VSP 98
October 18, 1989

SUBJECT: Textron Lycoming Service Bulletin Number 486

Service Bulletin No. 486
Engineering Aspects are
FAA Approved

Inspection of **Single Belt** Driven Ring Gear Support Assemblies

Figure 1. Starter Ring Gear Inspection Areas

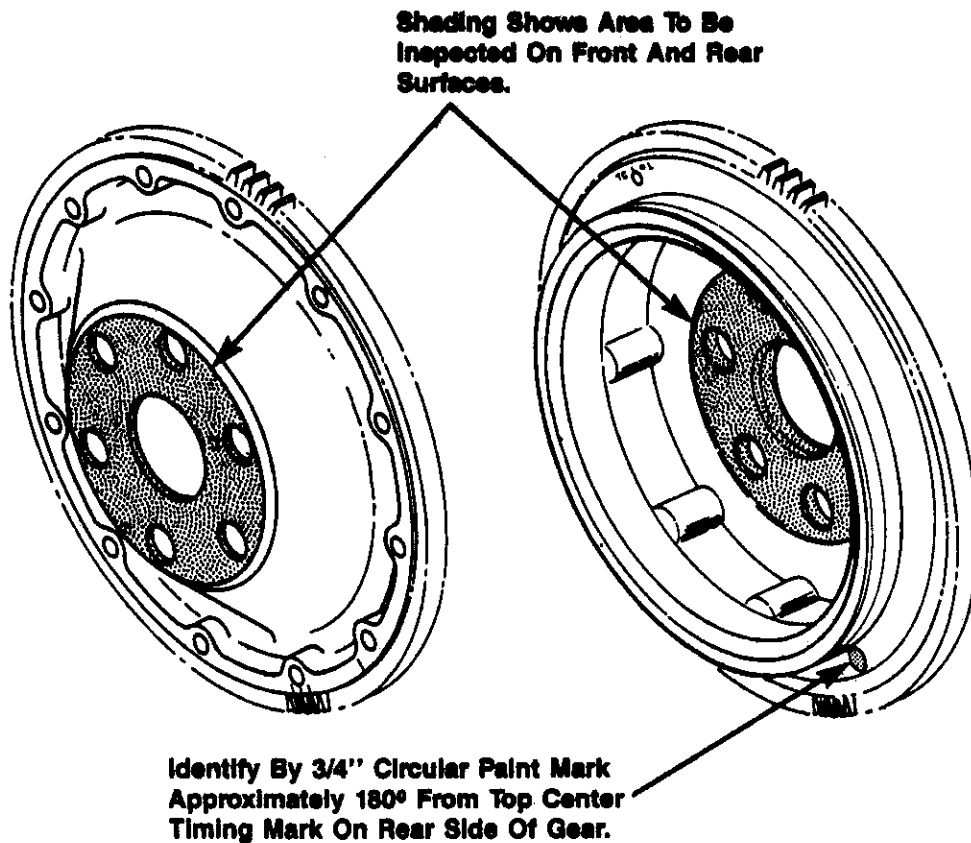
It has been discovered that a small quantity of Starter Ring Gear Support Assemblies installed on engines and shipped as spares between January 1, 1988 and June 12, 1989 may exhibit one or more cracks on the front and/or rear machined surfaces. The crack or cracks may appear at any point on the surfaces mating with the crankshaft/propeller flange. See Figure 1, Page 5.

After removal of the starter ring gear support, inspect the support assembly in the areas shown in Figure 1, Page 5, using a dye penetrant to insure no cracks are evident. Follow the penetrant manufacturer's instructions to perform the inspection.

If no cracks are found, the starter ring gear support assembly must be identified with a yellow circular paint mark approximately 3/4 inch in diameter located 180 degrees from top dead center mark on the rear side of the support assembly. See Figure 1, Page 5.
